A417 Missing Link
TR010056

8.5 Cotswolds Conservation Board
Options Report

Cotswolds Conservation Board Options Report

Regulation Number:	
Planning Inspectorate Scheme Reference	TR010056
Application Document Reference	8.5
Author:	A417 Missing Link

Figure 5-1 CCB Birdlip Bypass

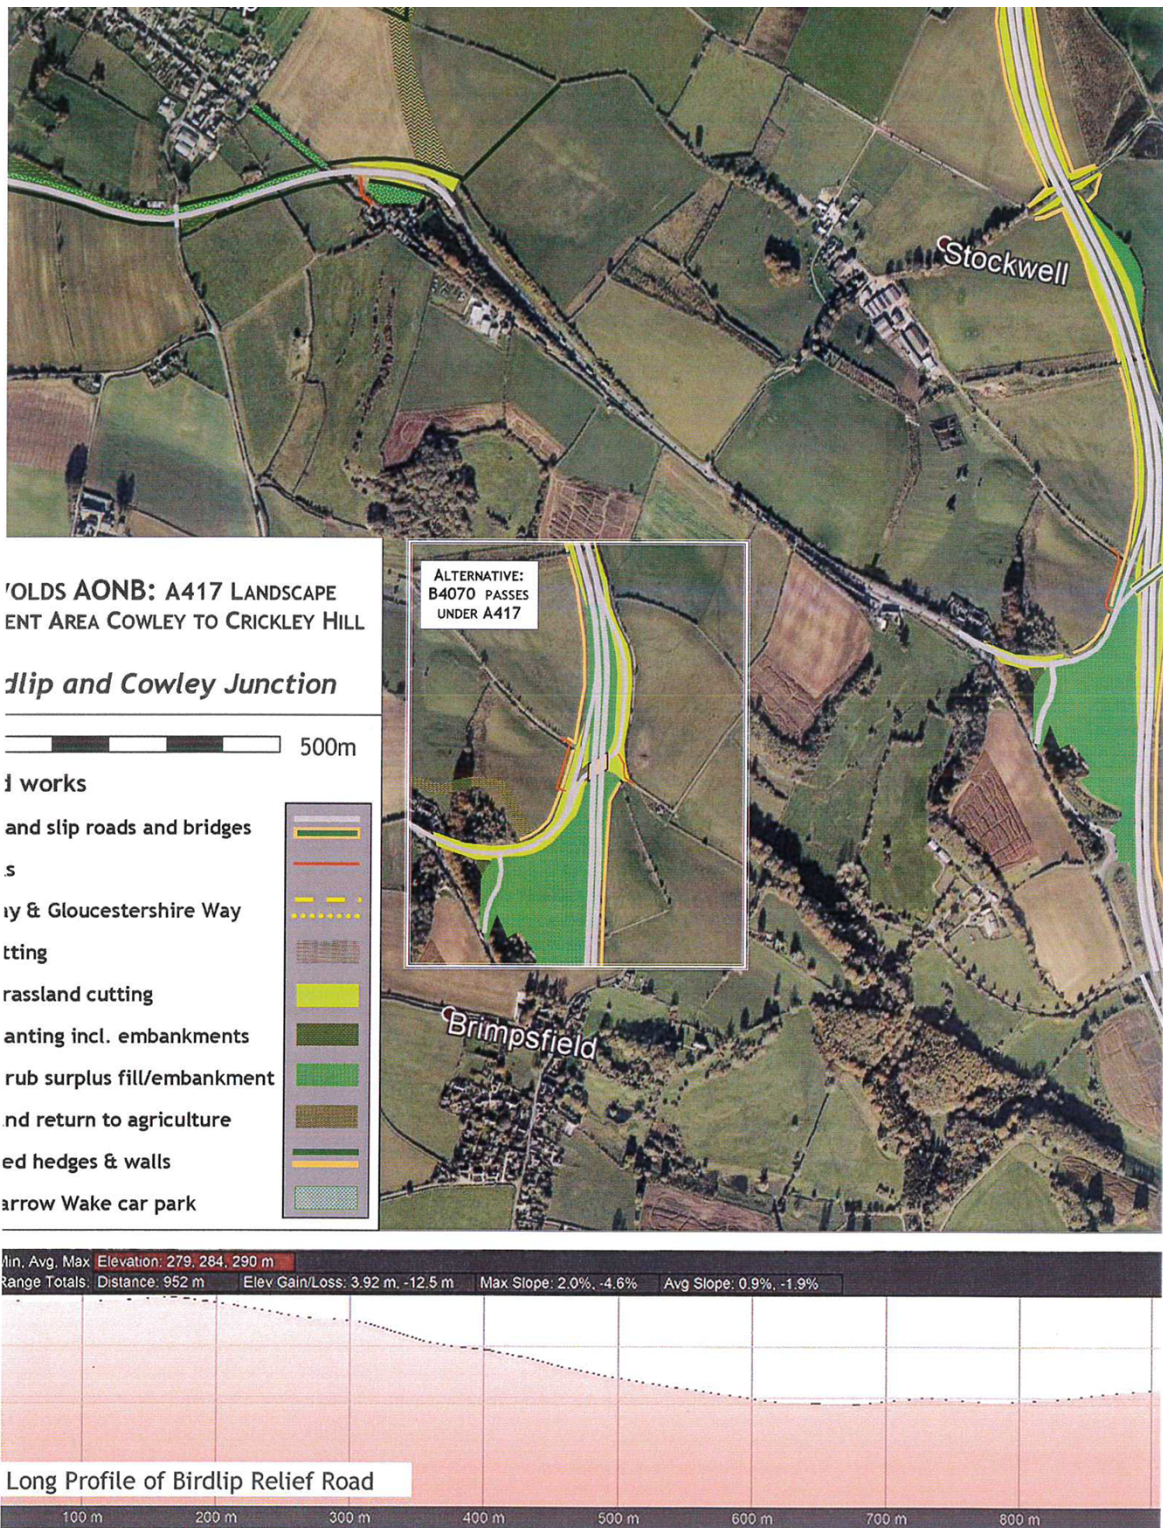
- 5.1.1 In May 2019 CCB submitted a letter to Highways England investigate the option for a section of bypass for Birdlip
- 5.1.2 Highways England assessed these options at the time and responded via letter on 28 August 2019. The result of that assessment is shown below.
- 5.1.3 CCB proposed an option for a section of bypass for Birdlip, taking the traffic from the Stroud - Painswick direction to the south of Birdlip to join the A417 at a revised Cowley junction arrangement as shown in Figure 5-1.
- 5.1.4 It was suggested that the route would avoid the need for the B4070 link road connecting to the north end of Birdlip and crossing the High Wold to Shab Hill, thereby avoiding the village.

- pass to the south of the village:
- be single carriageway road similar in character to existing local roads in terms of verges and landscaping
- follow the existing ground level at grade.
- Incorporate at grade crossroads and T junctions at minor roads (or mini roundabouts if essential).
- topsoil mounding to the north as noise barrier and limestone grassland and avoiding off site spoil disposal.
- minor planting in severed corners of fields.
- Shab Hill junction would be amended to remove the current Birdlip link road.

Figure 5-2 Indicative Plan of CCB Overall Proposals

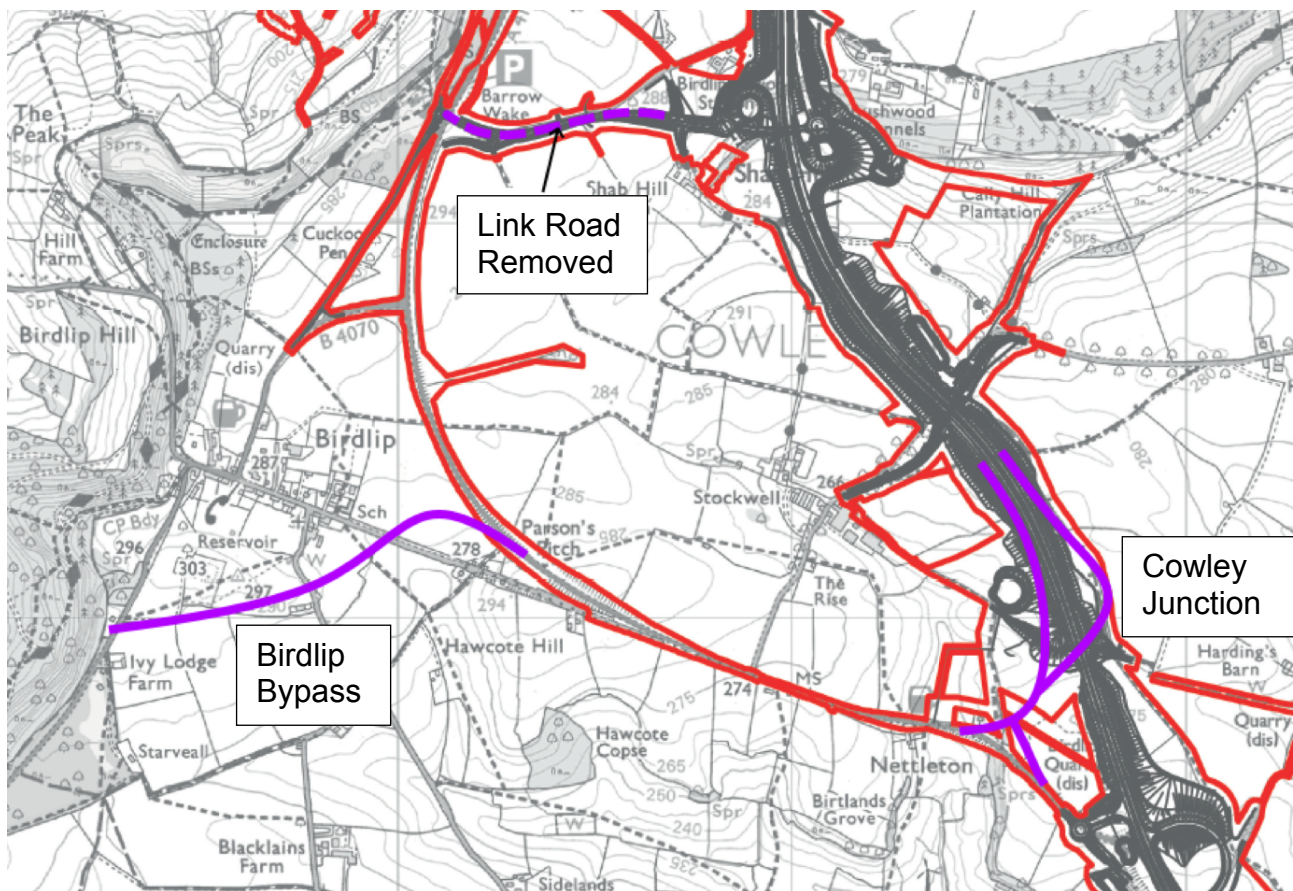
5.3.1 The appraisal of the Birdlip Relief Road proposal considered a range of factors including highway geometry, journey times, safety, cost and environmental impacts (e.g. noise, air quality, landscape) and compared them to the proposed B4070 Birdlip link road. Figure 5-2 shows an indicative layout of CCB proposals.

Removal of West Shab Hill Connection (B4070 Birdlip link road)

- 5.3.2 Local journeys between Birdlip and Cheltenham currently use the existing B4070 and A417 via the Air Balloon roundabout.
- 5.3.3 To limit the adverse effect on local journeys, connectivity routes would generally need to be as close to the existing Air Balloon Roundabout as possible and continue to offer access to all current directions.

- 5.3.4 Shab Hill junction would provide this connectivity. It is grade separated and would include four slip roads offering full access to the A417 in both directions. It would also provide connectivity between Cheltenham and Birdlip via the underbridge and A436 link road.

- 5.3.5 Removing the western connection from Birdlip to Shab Hill junction would mean that northbound/westbound traffic from the B4070 Birdlip area would need to travel via Birdlip bypass and the Cowley junction which would add approx. 2.8km to the journey

- 5.3.6 Similarly removing the west connection to Shab Hill junction would mean that eastbound traffic from the B4070 Birdlip area would need to travel via the Cowley junction and use the new A417 to travel north and turn around a Shab Hill approx. 3.2km to the journey.

- 5.3.7 A modification to include a westbound diverge and eastbound merge would remove the 3.2km detour, however, this would be at additional cost and have more environmental impact.

- 5.3.8 It is concluded this proposal would increase journey times and would likely reduce the BCR.

Figure 5-4 Outline Design of CCB Birdlip Bypass Proposal (Profile)

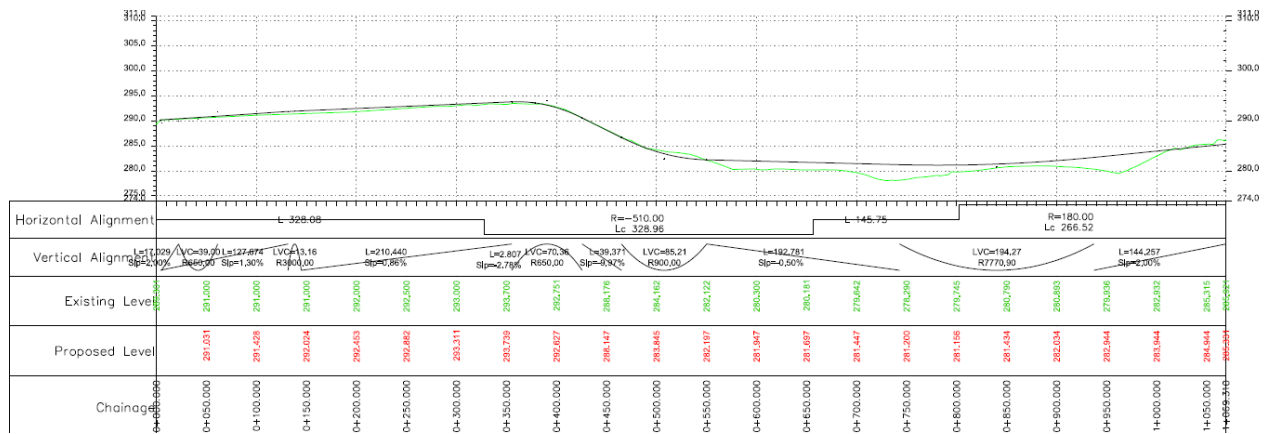
- 5.3.9 To evaluate the proposals an outline design of the suggested alignment for the Birdlip bypass was undertaken. These are indicated in Figure 5-1 and Figure 5-3.

- 5.3.10 In order to assess the feasibility of the Birdlip bypass it was compared to baseline option presented for consultation in October 2019. An evaluation matrix was used to compare various aspects of the design. This is included in Appendix A.

- 5.3.22 Overall, the route would present alignment challenges both horizontally and vertically to achieve a safe and compliant design. The horizontal and vertical curvature required to follow the suggested route would require several Departures from Standard (DfS) which would require justification in terms of safety.

5.3.25 Table 5-1 indicates the number of relaxations required to achieve the CCB alignment. These would in most cases represent Departures from Standard however certain amendments to the design could be made to reduce them however that would involve introducing large cuttings or embankments and wide verges to improve visibility.

Figure 5-5 Example of Mini Roundabout

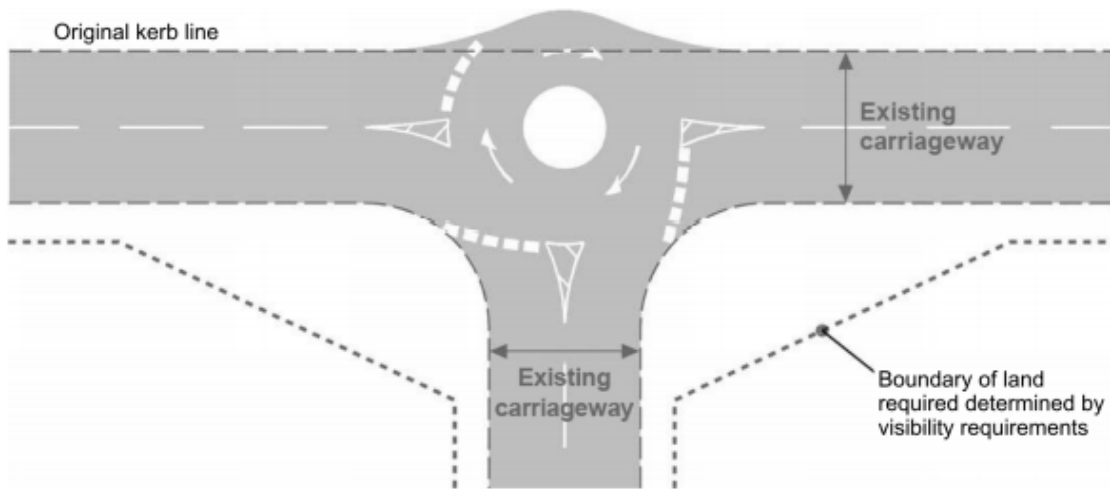
- 5.3.17 The suggestion of mini roundabouts such as those indicated in Figure 5-5 is noted however these are only permitted in urban settings where the speed limit is less than 30mph.

- 5.3.18 A smaller normal roundabout would be more appropriate in rural settings however this would have a larger footprint and associated impact.

Figure 5-8 2019 B4070 Link Road compared to revised 2020 proposals

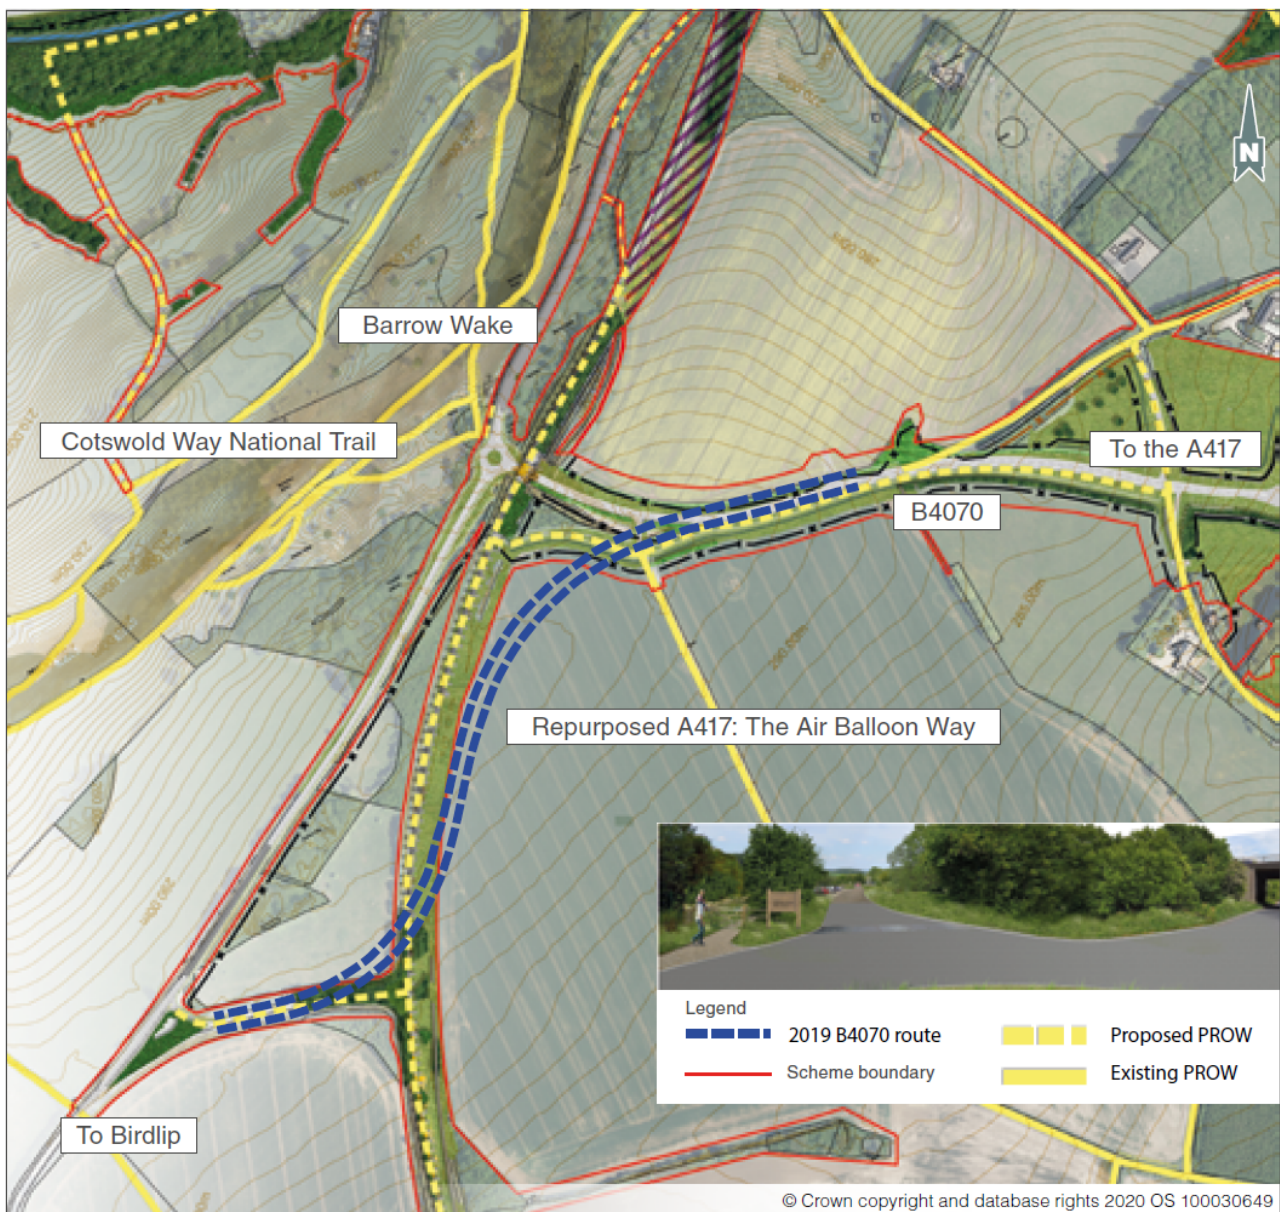
- 5.3.38 During the scheme 2019 consultation there were several objections to the route of the B4070 Birdlip link road presented including opposition of several landowners.
- 5.3.39 There were also calls to improve facilities, parking and accessibility at Barrow Wake and concerns about the proposed alignment of the B4070, which crossed the repurposed A417, and resulted in the loss of agricultural land. There were also concerns expressed regarding antisocial behaviour at Barrow Wake. CCB also objected to the affect the route would have an adverse effect on the High Wold
- 5.3.40 As a result of discussions with Gloucestershire County Council several amendments have be made to the B4070 link road.
- 5.3.41 The original proposals presented at the public consultation in Autumn 2019 provided a link which would cross the fields and tie in to the existing Birdlip junction. See Figure 5-8.

5.3.42 The revised alignment would follow the existing single track alignment and use the existing underpass near Barrow Wake to connect to the original alignment of the A417. This has several advantages:

- Removes the need for a Walking, Cycling and Horse-Riding crossing on the repurposed A417
- Helps regulate traffic speed on B4070
- Provides natural surveillance of Barrow Wake car park, helping to manage antisocial behaviour
- Discourages use by large goods vehicles
- Reduces visual intrusion across the high wold
- Reduces land take.
- Utilises existing infrastructure.
- 600m less additional carriageway

Figure 6-1 CCB Alternative Shab Hill Junction Arrangement and A436 Alignment

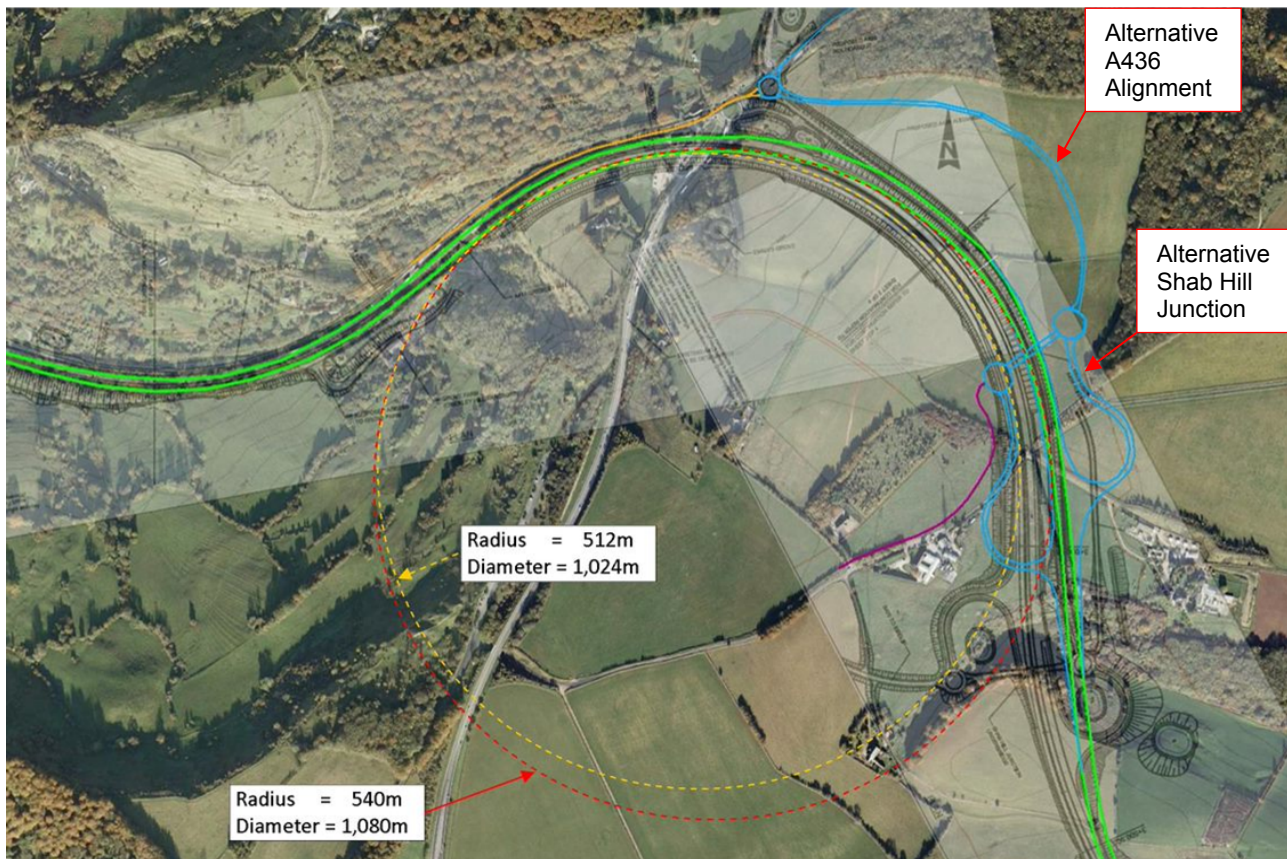
- 6.1.1 CCB recommended that Highways England considered relocating the proposed Shab Hill junction a few hundred metres further north. See Figure 6-1

- 6.1.2 CCB suggested that the A436, the roundabouts and the road connecting the roundabouts could generally be close to existing ground levels, with the A417 passing underneath in the cutting (and emerging not much above ground level at the dry valley where the Shab Hill junction is currently proposed)

- 6.1.3 CCB believed that this design option would significantly reduce visual and noise intrusion at Shab Hill Farm and Rushwood Kennels; noise pollution and visual impacts on the wider landscape; and adverse impacts on the head of the Upper Churn Valley. It would also allow for shallower gradients of the A417 and for the Gloucestershire Way to more closely follow its current route and provide a more pleasant walking experience on this route.

- 6.2.5 The Gloucestershire Way Crossing was introduced to provide an ecological corridor giving connectivity between habitats for flora and fauna including bats. The relocation of Shab Hill junction would adversely affect these proposals.

- 6.2.6 It would be difficult to combine the crossing with the Shab Hill junction arrangement and provide an adequate level of ecological mitigation without a very wide, long likely skewed structure which would be prohibitively expensive.
